Technical and Regulatory Guidance for Using Polyethylene Diffusion Bag Samplers to Monitor Volatile Organic Compounds in Groundwater

February 2004

Prepared by
Interstate Technology & Regulatory Council
Diffusion Sampler Team

Response to Technical Comments

Figure 1-2. (right) Comparison of diffusion and pumped samples in groundwater showing relative uniformity in vertical distribution of trichloroethene concentrations in the screened interval of a well (modified from Vroblesky et al. 2003).

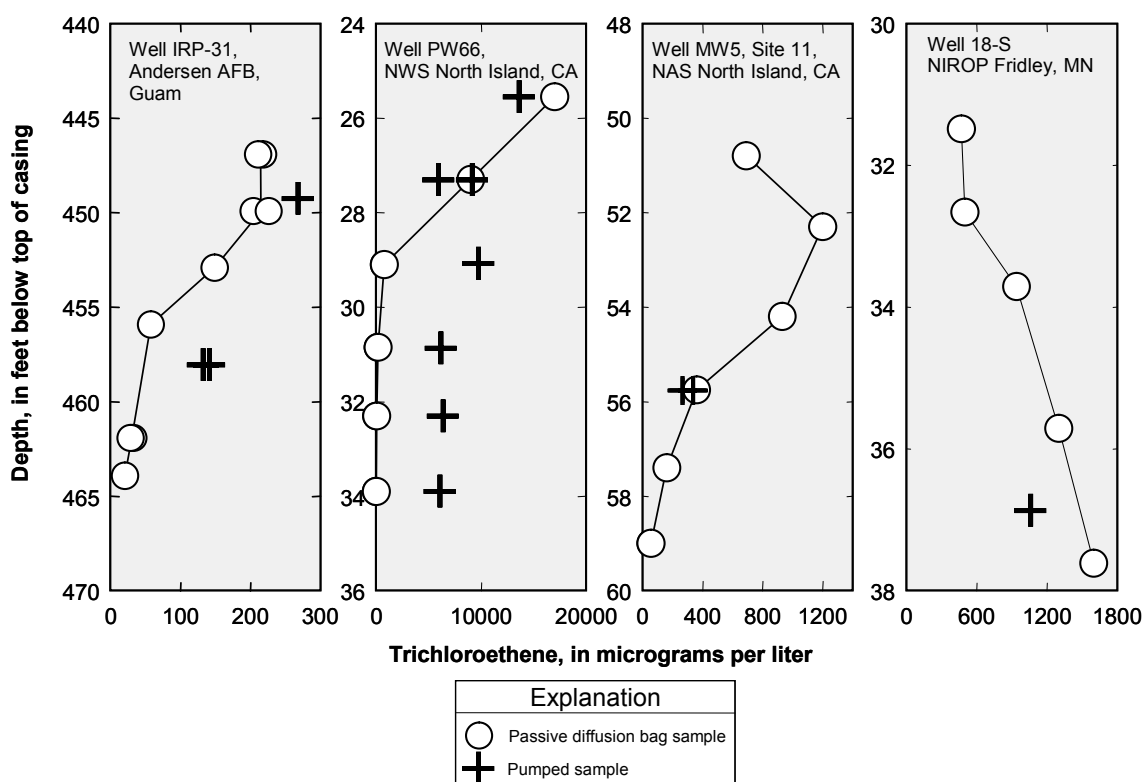
10. P.11, L.11-16: The intent of the discussion regarding Figure 1-2 is not apparent. Either the last sentence should be omitted or the thought process behind the last statement should be clearly presented. As it stands, the discussion provides two possibilities to explain the data in Figure 1-2, then dismisses the second possibility without explanation.

21. Figure 1-2: Statement “The pump produces a mixture of contaminated and uncontaminated water.” This statement also be included in Figure 1-3. While it is true that more of an averaged value is obtained with pumps, this effect is less with PDBs although they don’t seal off a specific zone within a screened interval, particularly in a 4-inch well (PDB diameter is 1.25 inches).

68. Page 3, Figure 1-2: The conclusion(s) that should be drawn from this figure is/are not clear to me. I suggest redrawing it, omitting one of the two curves included, or omitting the entire figure. Simply including a reference to the statement that “contamination stratification has been observed” may suffice.

Figure 4-1. Regulator responses regarding the use of PDBs for various purposes.

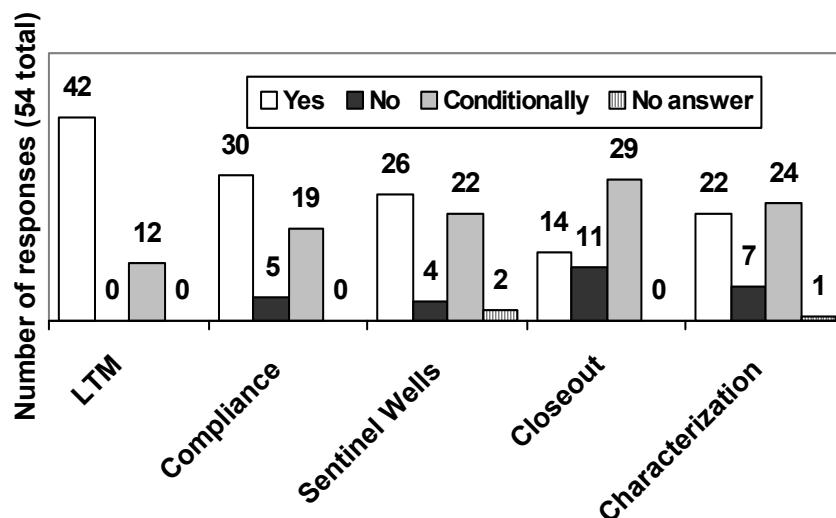
36. Page 36, Line 6: The question asked to be paraphrased and not quoted. Where is the reference to Figure 4-1? Figure 4-1 on page 37 should follow this section on page 36.

This paragraph has been modified and reference to the figures clarified.

Figure 4-2. PDB survey results from 23 states indicating regulator support for specific uses of PDBs.

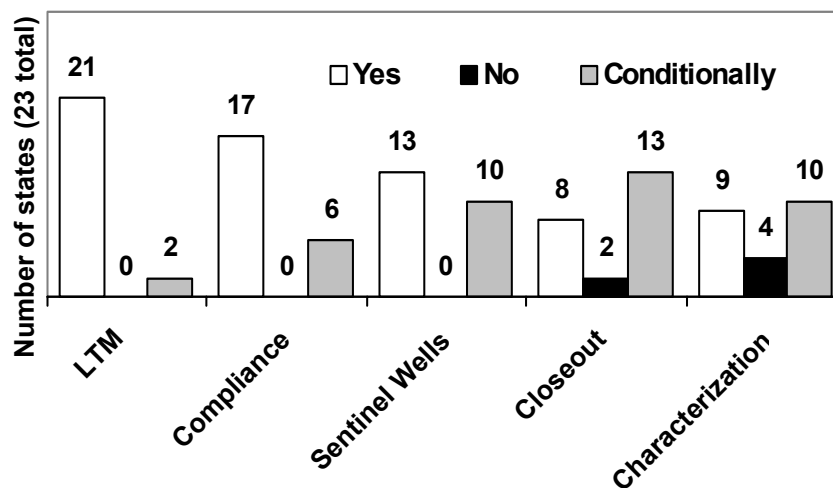
37. Page 38, Lines 5-7 and Figure 4-2: It is misrepresenting the states’ responses to include only one positive response to closeout while a majority may have rejected it.

38. Figure 4-2 Caption: Too many prepositions. Reword “PDB survey results from 23 states indicting regulators acceptability to specific uses. . . .”

There is no best way to condense multiple responses from a given state. The approach taken—to display the response most favorable to PDB sampling—is not a misrepresentation but one alternative that was clearly presented as such. The reader is free to consult the data in Appendix D to conduct his own analysis. The caption for Figure 4-2 has been modified to call attention to the assumptions stated in the text.
